NORTHERN STATES POWER COMPANY
PRAIRIE ISLAND NUCLEAR GENERATING PLANT

REQUEST FOR AMENDMENT TO
OPERATING LICENSES DPR-42 & DPR-60

LICENSE AMENDMENT REQUEST DATED May 7, 1997
Amendment of Spent Fuel Pool Special Ventilation System Specifications

Amendment of Spent Fuel Pool Special Ventilation System Specifications

FIGURE 1
EXHIBIT A
SPENT FUEL POOL ENCLOSURE

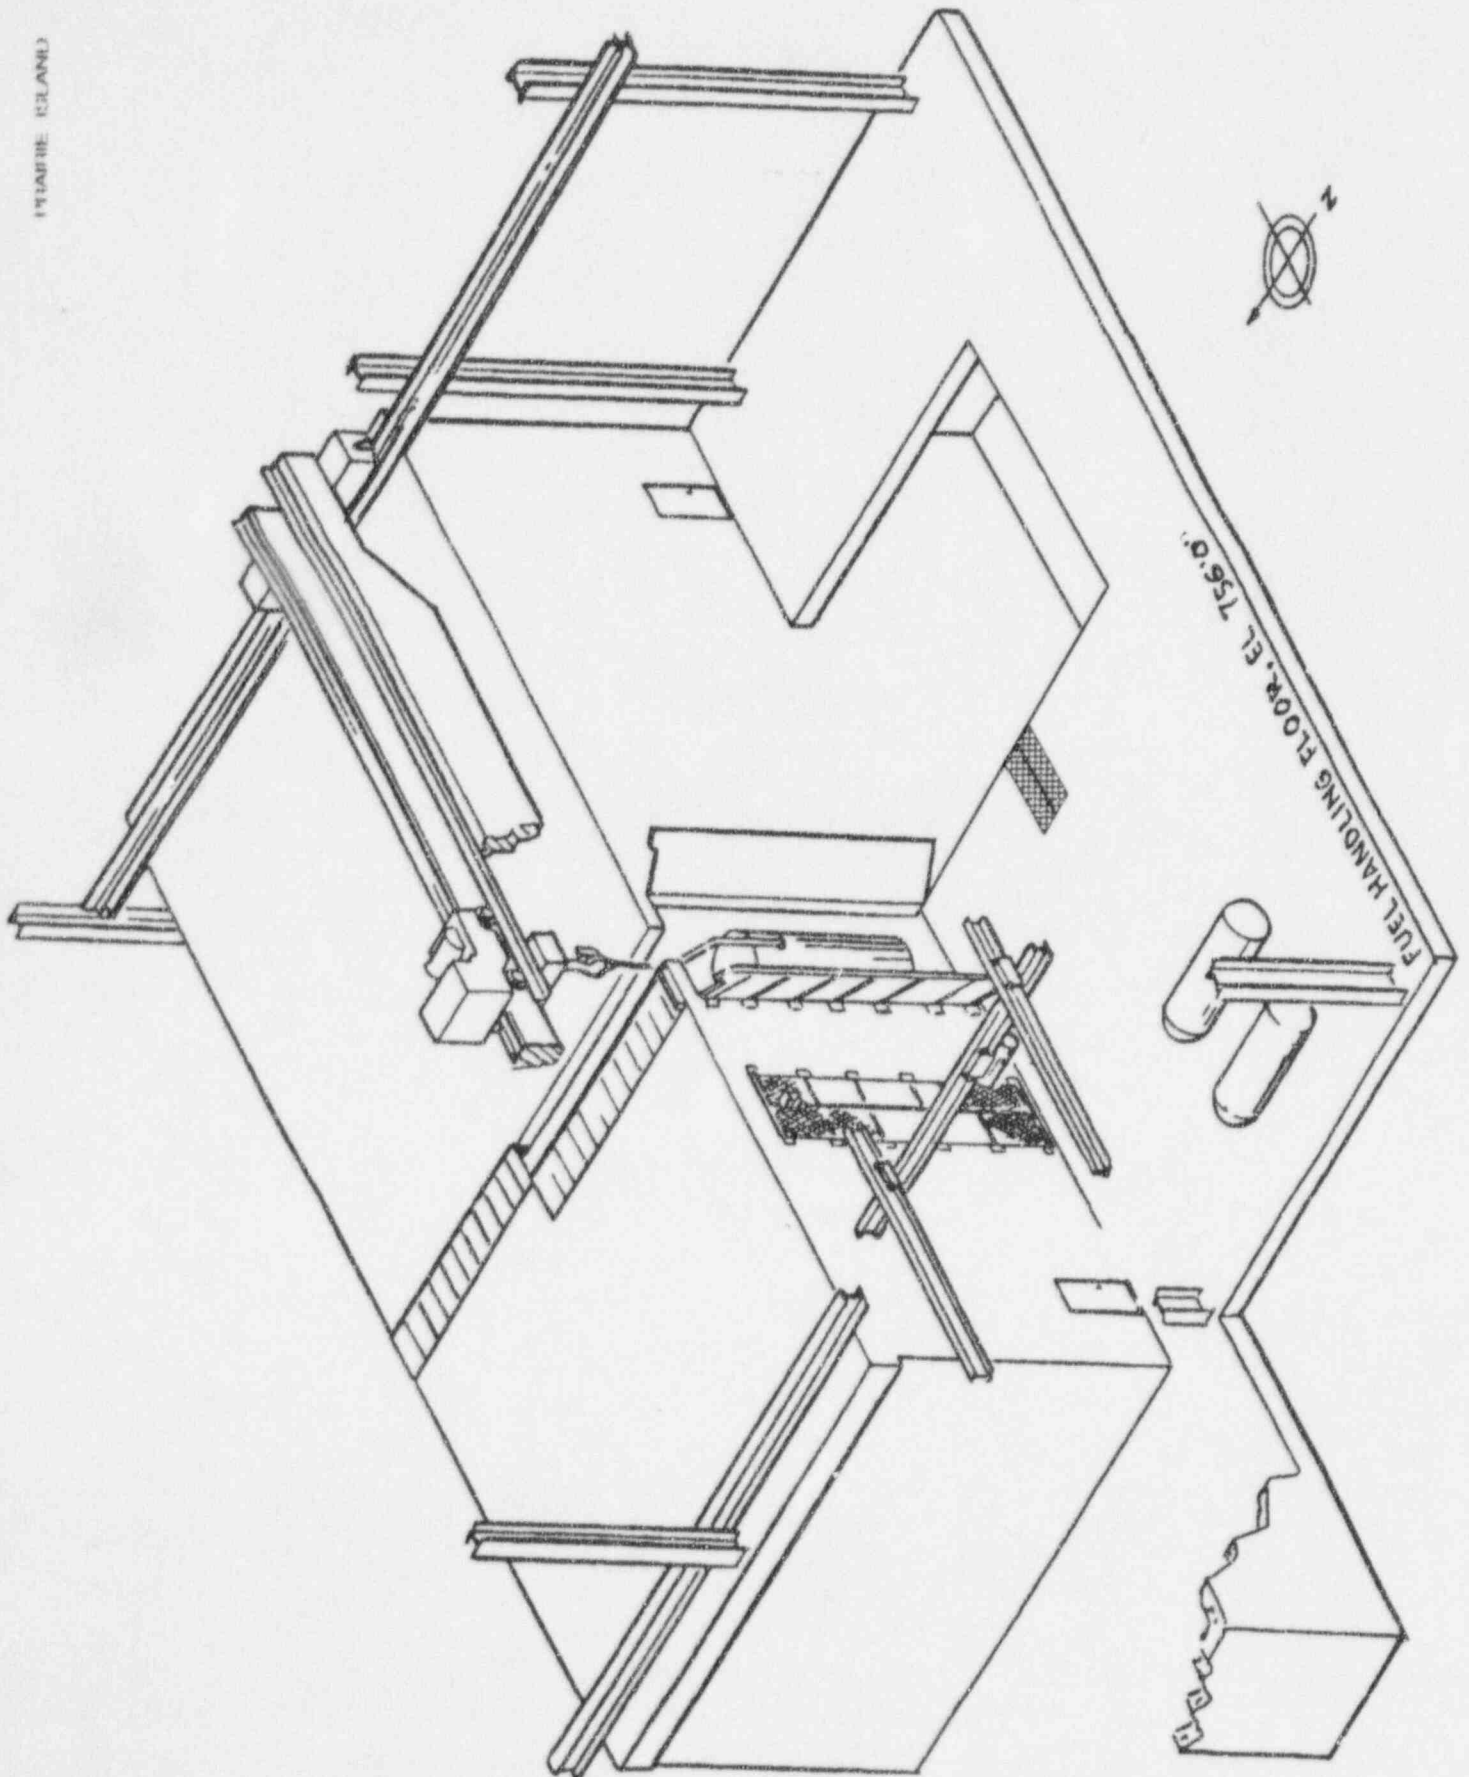
Figure 1 shows the auxiliary building crane moving a load into the spent fuel pool enclosure. In order for the auxiliary building crane to move loads into the spent fuel pool enclosure or to move loads to the auxiliary building central court, north of the spent fuel pool enclosure, the large access doors and the roof slot doors of the spent fuel pool enclosure must be open.

negative pressure within the enclosure and therefore both trains of the spent fuel pool special ventilation system are inoperable. In order to move loads into the spent fuel pool enclosure or into the auxiliary building central court area through the spent fuel pool enclosure, the enclosure roof slot doors and the large north and south access doors are required to be opened. Therefore, when loads are handled by the auxiliary building crane in the spent fuel pool enclosure, both trains of the spent fuel pool special ventilation system are inoperable.
